RE: Uranerz Energy Corporation, Nichols Ranch Project, Source Materials License SUA-1597, Docket No. 40-9067, License Condition 12.8 Request for Additional Information Response

**Uranerz Energy Corporation Nichols Ranch ISR Project
Responses to the NRC Request for Additional Information, Pre-operational License
Condition 12.8, February 14, 2014.**

Figure 3, Nichols Ranch Wind Rose Comparison

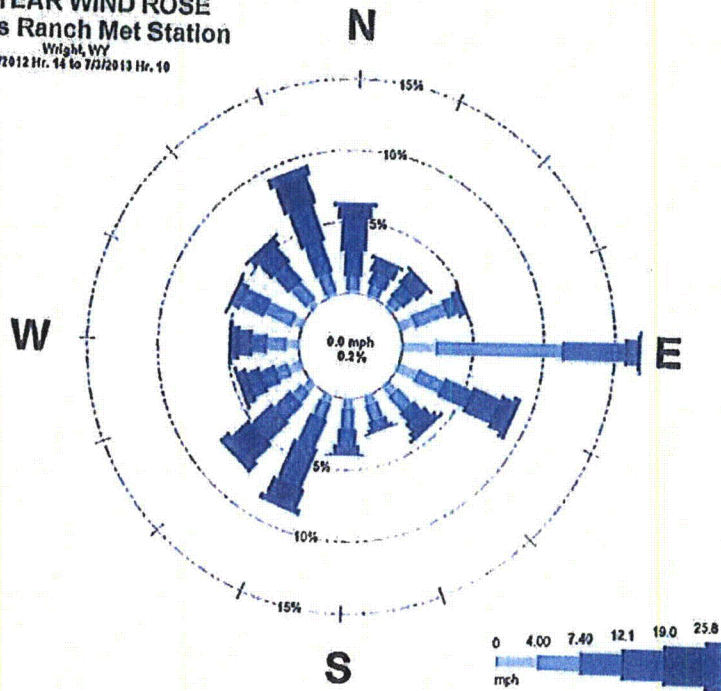
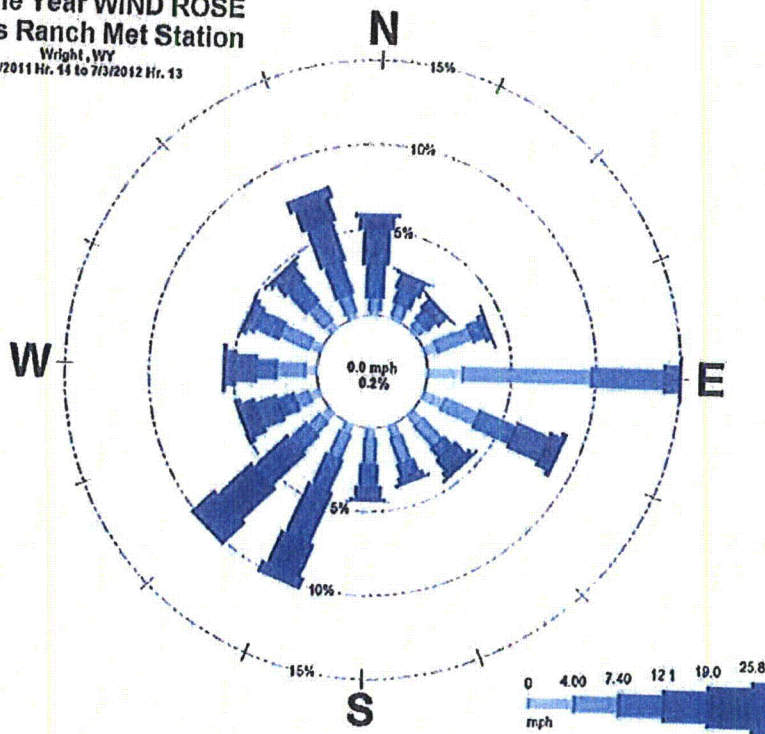
The licensee reviewed local meteorological data (see Appendix B) to meet requirements in license condition 12.7. This review was completed in order to determine if changes need to be made to environmental air monitoring stations. The review for proposed changes will take place under a Safety and Environmental Review Panel (SERP) to determine if proposed changes will meet the NRC requirements for sampling of air particulates and radon air samplers. Any approved changes must not change both basic health and safety requirements and basic potential environmental impacts assessed as part of the licensing process. The review panel will also take into account radiological considerations in order to maintain the As Low As is Reasonably Achievable (ALARA) principle.

Figure 2-25, Nichols Ranch Unit Radon/Gamma/Air Particulate Monitoring Locations

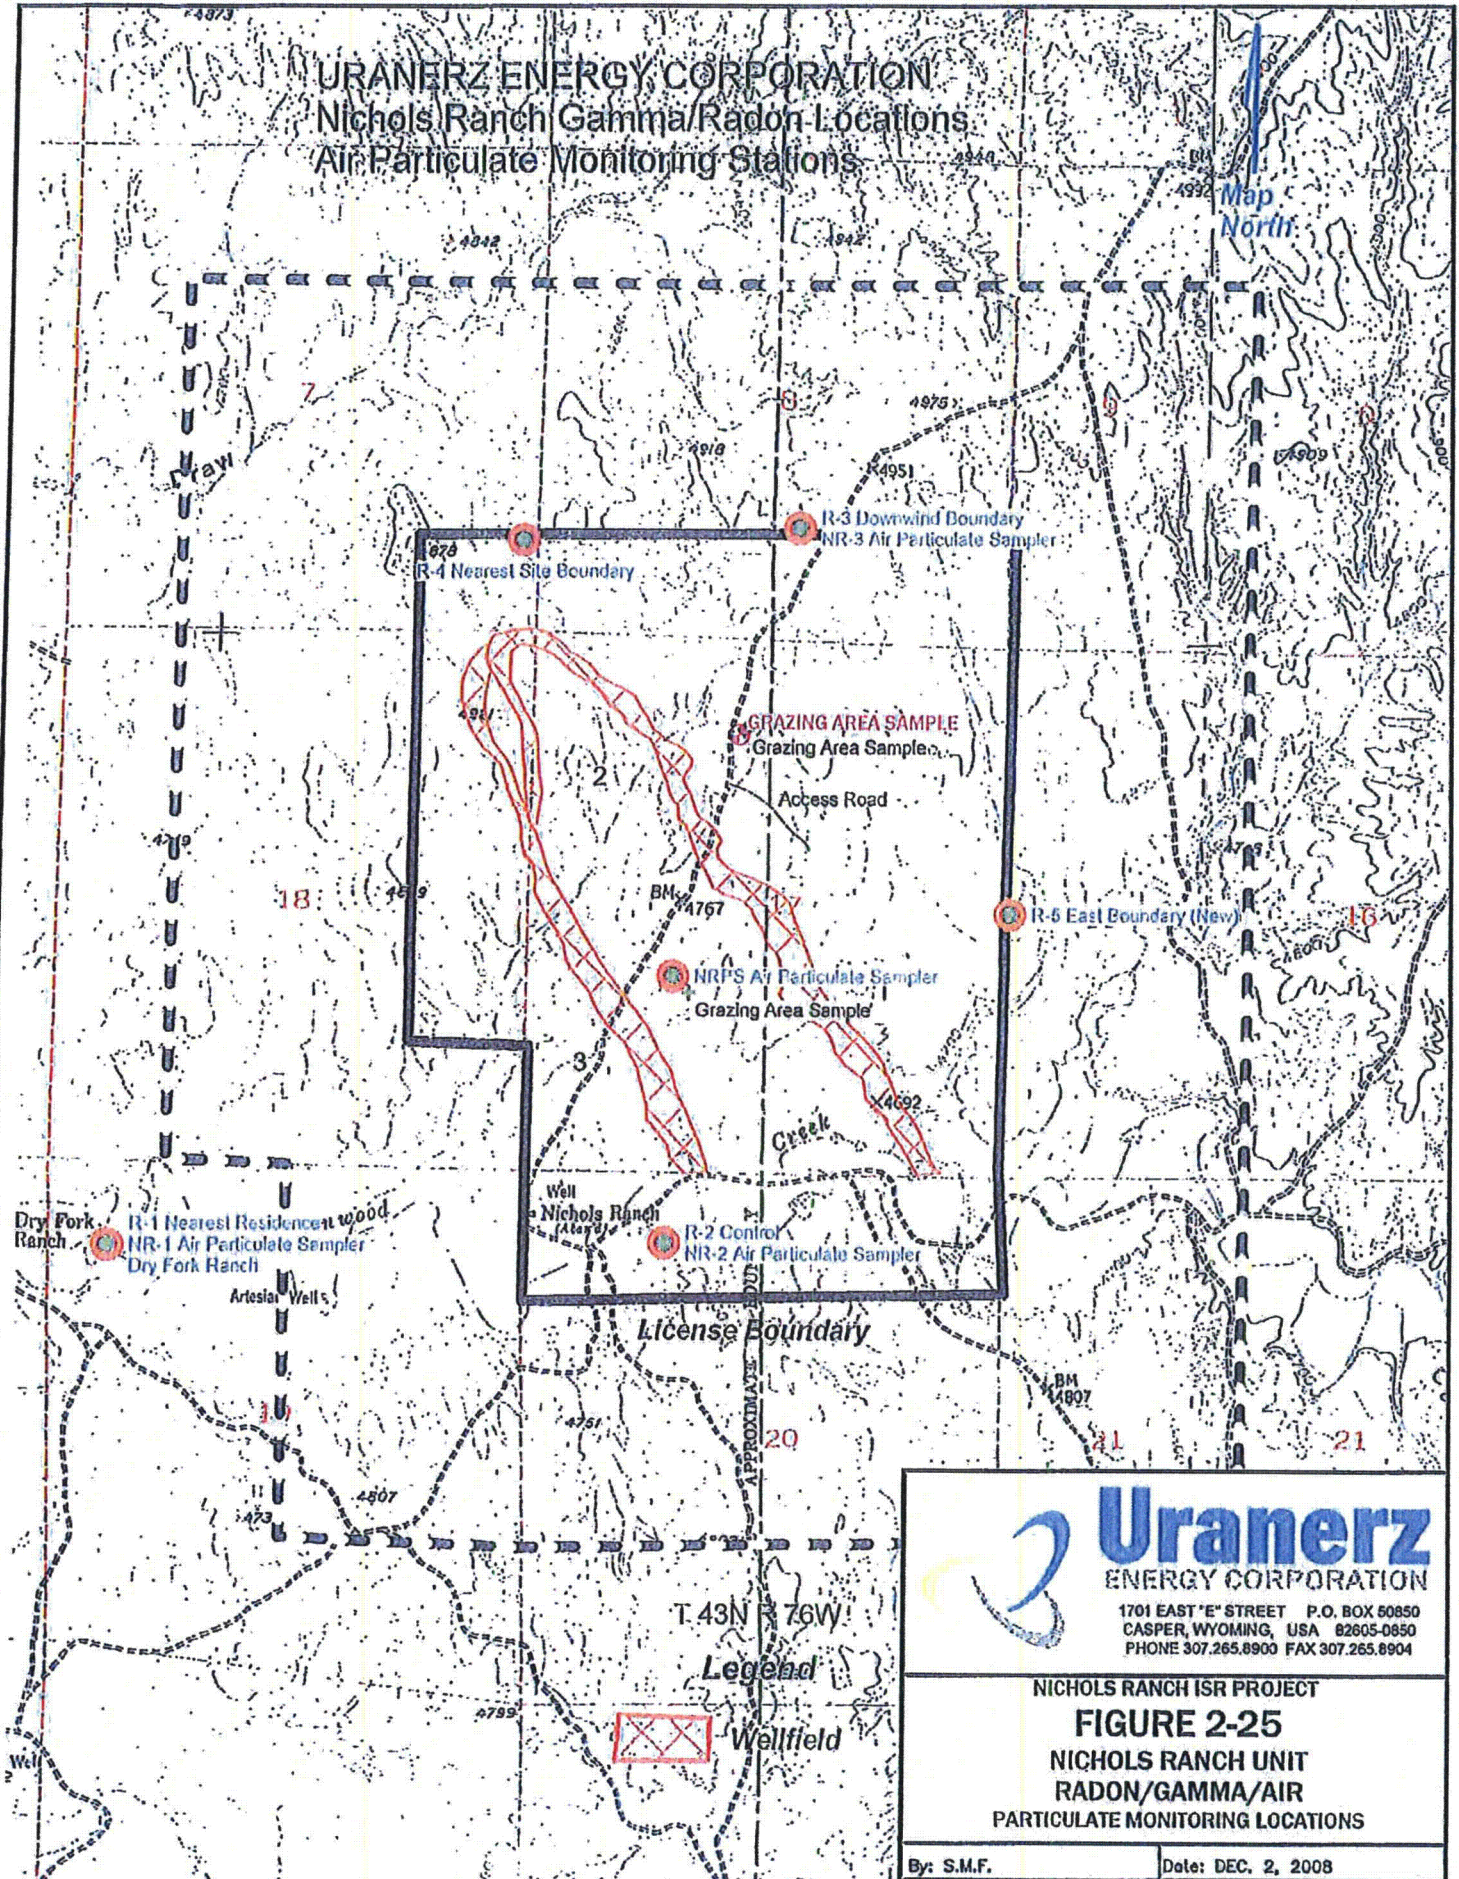
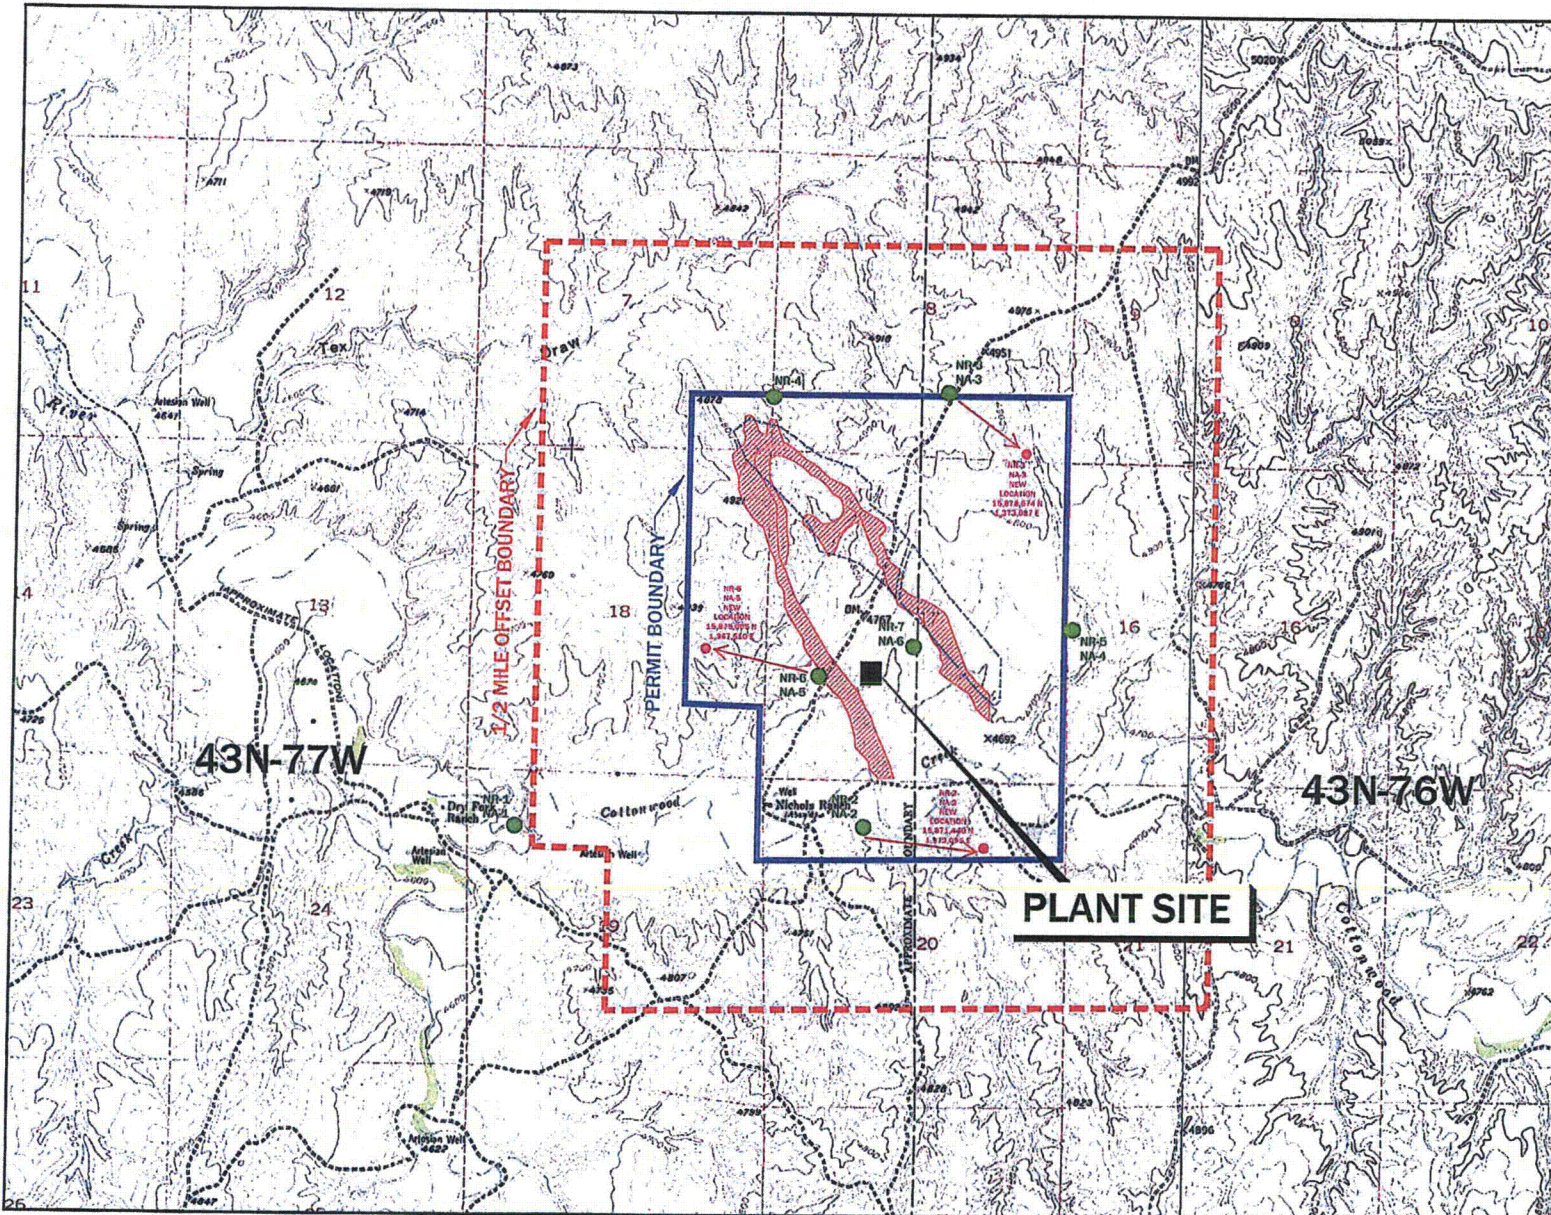
The proposed change to the license is to Figure 2-25 (see Appendix C) which is a map describing the location of baseline environmental air samplers. For a map of current environmental sampling locations see Appendix D. After review of on site meteorological data the licensee has determined that the three sectors with the highest predicted radioactivity concentrations resultant from operations is: 1) west of processing plant, 2) north-northeast of processing plant, and 3) south-southeast of processing plant. Taken this additional information the licensee has proposed new locations for environmental air samplers (see Appendix E). This change includes moving sample location NA-2 and NR-2 further to the east, moving sample location NA-5 and NR-6 closer to the western boundary, and also moving NA-3 and NR-3 closer to the northeast boundary. Another proposed change would be changing the background sample location from NA-2 to NA-4. These changes are to be implemented in order to ensure the licensee is in compliance with NRC Regulatory Guide 4.14 and license condition 11.9.

Figure 2-25 Revision 2, Nichols Ranch Unit Radon/Gamma/Air Particulate Monitoring Locations
